Product Change Notification

Change Notification #: 113772-00 - 00

Change Title: Intel® Server System R2312GZ4GS9
PCN 113772-00, Product Design and Label
Update the System Rear Panel, 750W Common
Redundant Power Supply Firmware, and the
Safety label with an EAC logo instead of a
GOST logo

Figure One

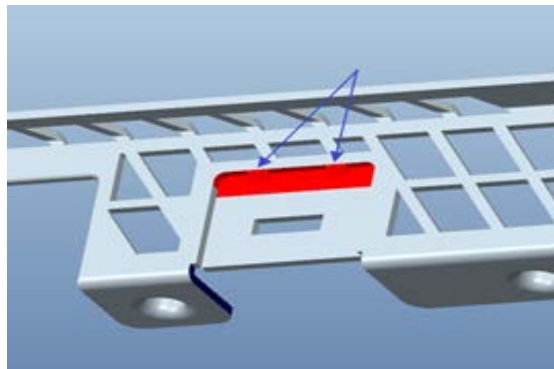
1. Update the one big center joint to two smaller joints so that the joints will not conflict with the LAN cable connector latch. See Figure One.

Figure Two

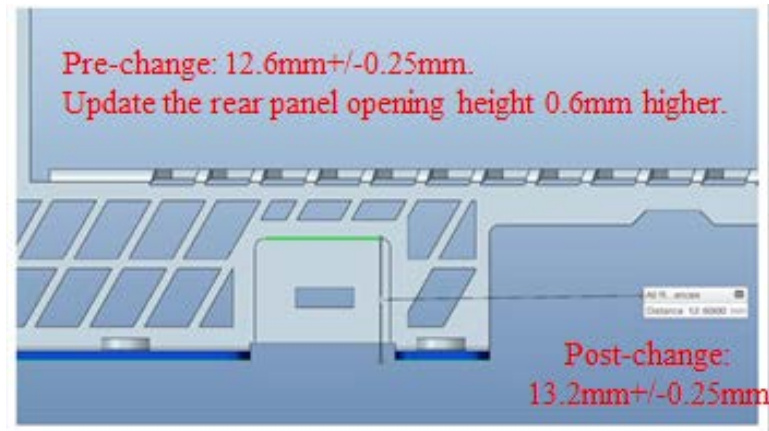
2. Update the rear panel opening height 0.6mm higher to improve the flexibility for the cable latch. The previous height was 12.6mm+/-0.25mm. The updated height is 13.2mm+/-0.25mm. See Figure Two.

Figure Three

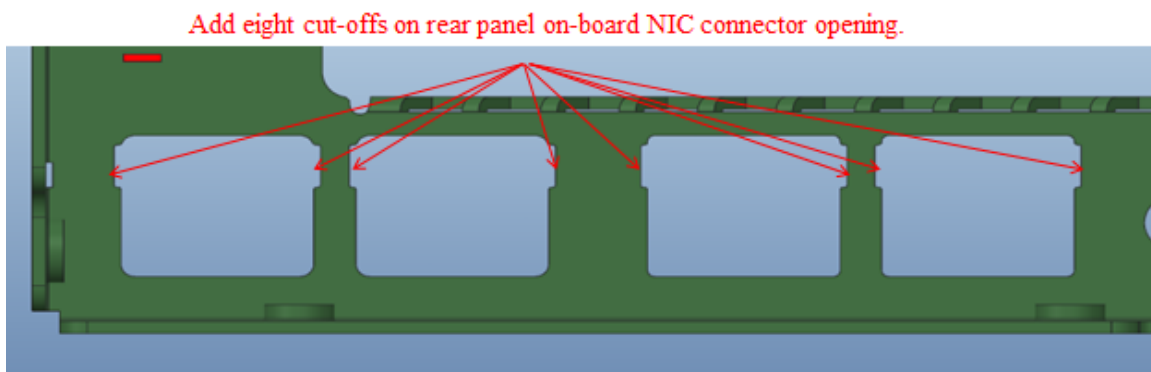
3. Add eight cut-offs around the on-board NIC (Network Interface Controller) openings to improve the LED visibility. See Figure Three.
